Access Compliance Report

Public Rights-of-Way

(Curb Ramps)

Intersection ID: 42773	Main Street: ERWIN_RIDGE_AV	Cross Street: SWANSONG_LN	Location: N
ADA ID: 5F4B78A9EF18	Ramp Type: PerpDiag	Initial Pass/Fail: Pass	Overall Compliance: No
Codes/Mitigation Info/Possible Solution		Field Measurements/Component Compliance

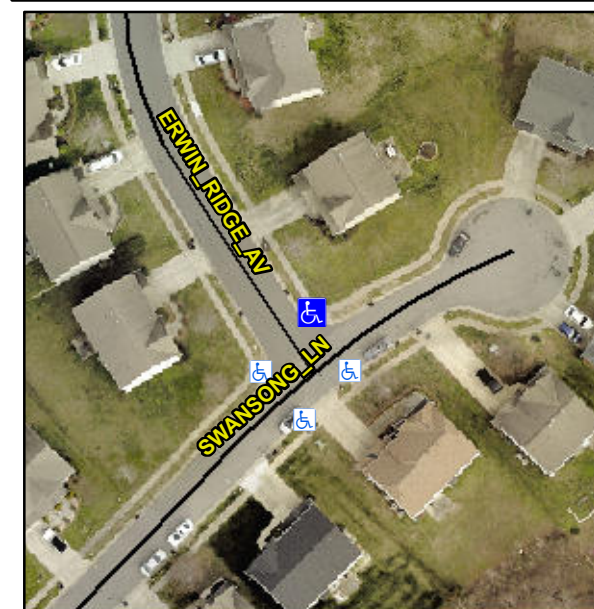
Not Found, R304.5.3, R305, R304.5.4

Compliance	Description	Data	Compliance	Description	Data
N/A	Ramp Length (in)	45.0	Yes	Ramp Slope (%)	6.9
Yes	Ramp Width (in)	48.0	No	Ramp XSlope (%)	2.7
N/A	Flare Type LT	Sloped	N/A	Flare Type RT	N/A
N/A	Flare Slope LT (%)	9.1	N/A	Flare Slope RT (%)	1.0
N/A	Flare Traversable LT?	No	N/A	Flare Traversable RT?	No
Yes	Landing Length (in)	48.0	No	DWS Provided?	No
Yes	Landing Width (in)	48.0	N/A	DWS Contrast?	No
Yes	Landing Slope (%)	2.0	N/A	DWS Length (in)	N/A
No	Landing X Slope (%)	4.1	N/A	DWS Full Width?	No
N/A	Landing Curb? (Y/N)	No	N/A	DWS Offset (in)	N/A
N/A	Shared Landing?	No			
Yes	Gutter Ponding?	No	No	Gutter Slope (%)	7.1
Yes	Gutter Lip Ht (in)	0.0	No	Gutter X Slope (%)	3.5
N/A	Painted X Walk1?	No	N/A	Painted X Walk2?	No
	X Walk 1 Direction	To SW		X Walk 2 Direction	To SE
N/A	X Walk 1 Width (in)	N/A	N/A	X Walk 2 Width (in)	N/A
	X Walk 1 Slope (%)	4.3		X Walk 2 Slope (%)	0.3
	X Walk 1 X Slope (%)	2.2		X Walk 2 X Slope (%)	4.5

Remove & Replace Curb Ramp With Two New Directional Ramps or Equivalent. Remove & Replace Gutter.
